Item ID: D350-607-545 Accept *N900040100* Setup Start *NS1*
 Revision ID: Stop *NS2*
 Item Name: QR Heli-Utility-Basket™, Short, HD Lid, Spacepod™ & Squirrel Cheek Comp., LH/RH
 Start Date: 3/09/15 Start Qty: 1.00 *1* Cust Item ID:
 Required Date: 3/18/15 Req'd Qty: 1.00 *1* Customer:
 Reference:

DART SERVICE INSTRUCTION

TO AMEND INSTALLATION INSTRUCTIONS D350-607-3 Rev.D,
INSTALLATION INSTRUCTIONS D350-607-4 Rev. C AND
INSTRUCTIONS FOR CONTINUED AIRWORTHINESS ICA-D350-607 REV. 6
REF TCCA STC: SH94-14
REF FAA STC: SR00213NY
REF EASA STC: EASA.10016996
REF BRAZILIAN STC: 2007S03-03/-04/-05/-06

FIGURE 1: INSTALLATION OF D4775-041 FWD STRUT

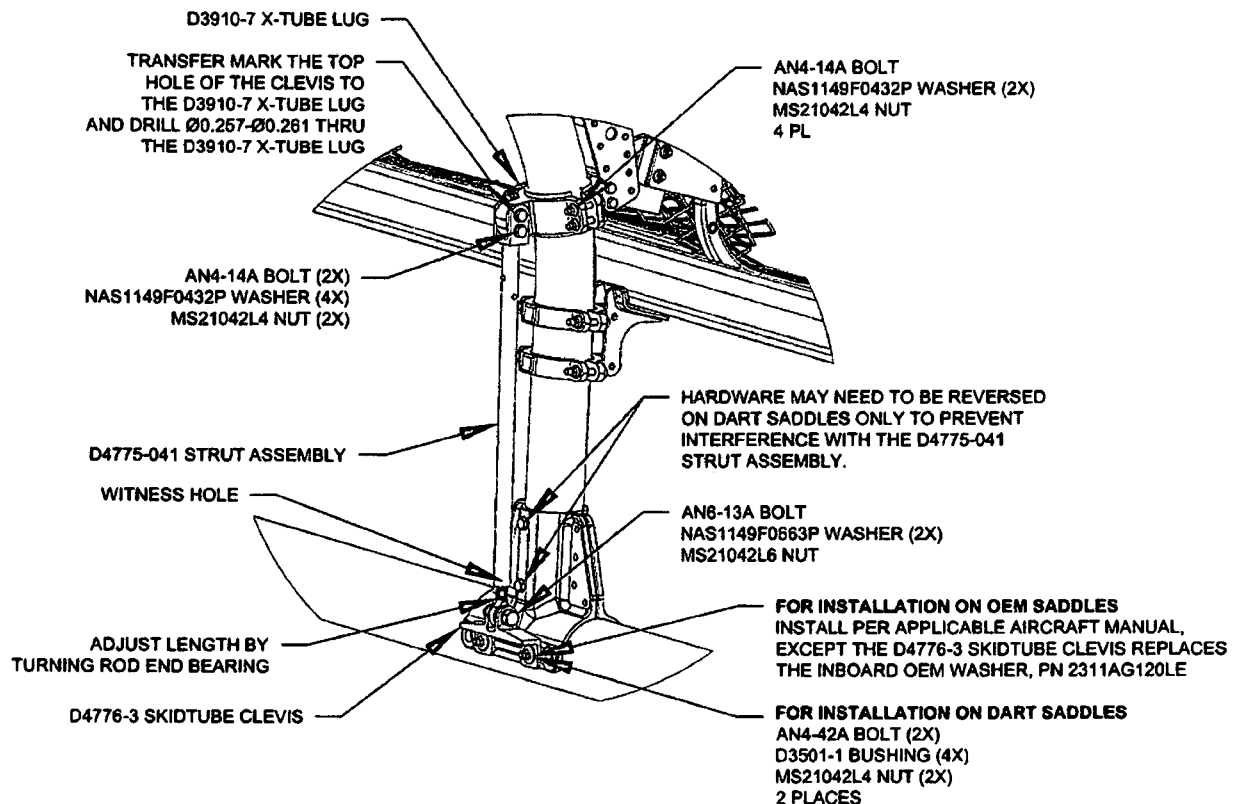
- 3.1 Substitute the Forward Lower D3910-5 X-Tube Lug with the D3910-7 X-Tube Lug as shown in Figure 1.
- 3.2 Install the forward D4775-041 Strut Assembly. Transfer mark from the upper hole on the clevis of the D4775-041 Strut Assembly to the D3910-7 X-tube Lug and drill thru the lug $\varnothing 0.257$ - $\varnothing 0.261$ as shown in Figure 1. Touch up chemical conversion coating per MIL-DTL-5541. Check the witness holes located at the bottom end of the D4775-041 Strut Assemblies to ensure that the thread from the rod end extends past the witness hole.
Torque MS21042L4/-4 nuts to 50-70 in-lbs (5.7-7.9 N-m). Torque MS21042L6/-6 nuts to 160-190 in-lbs (18.1-21.5 N-m).
- 3.3 Complete the installation in accordance with Installation Instructions D350-607-3 Rev. D or D350-607-4 Rev. C.
